UNITED STATES PATENT AND TRADEMARK OFFICE

Office Action Summary

09/688,989

DETAILED ACTION

FIG. 3(d)

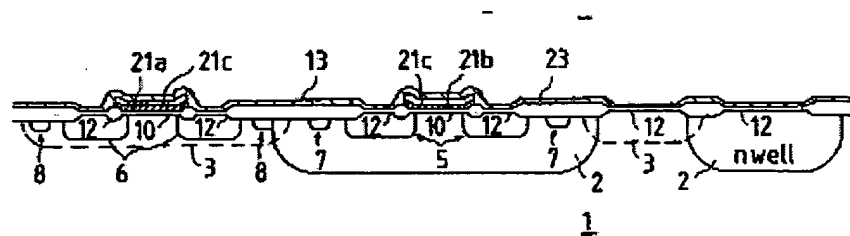
Applicants contend that Tada does not disclose/ suggest that the sidewalls of the gate electrodes are connected.

However Tada in Figure 3D shows element (21) connecting gate electrodes sidewalls 13 a and b. (reproduced below).

Therefore contrary to applicants' contention all of the presently recited limitations of the claims, including sidewalls of the gate electrodes 13 a and 13 b are connected by element (polysilicon layers) 21 a and 21 b (col. 8 lines 1-11) is taught , (and to the extent understood " a sidewall of the first gate electrode at one end of a channel direction is connected to a side wall of said gate electrode at one end of the channel

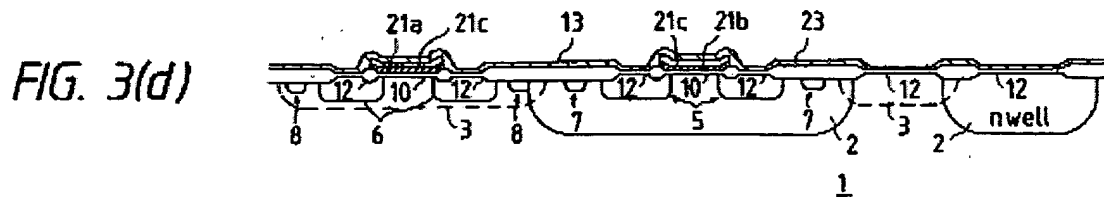
Applicants contend that Tada does not disclose/ suggest that the sidewalls of the gate electrodes are connected.

However Tada in Figure 3D shows element (21) connecting gate electrodes sidewalls 13 a and b. (reproduced below).

Therefore contrary to applicants' contention all of the presently recited limitations of the claims, including sidewalls of the gate electrodes 13 a and 13 b are connected by element (polysilicon layers) 21 a and 21 b (col. 8 lines 1-11) is taught , (and to the extent understood " a sidewall of the first gate electrode at one end of a channel direction is connected to a side wall of said gate electrode at one end of the channel direction") by Kume and Tada and therefore prima facie obviousness has been established.
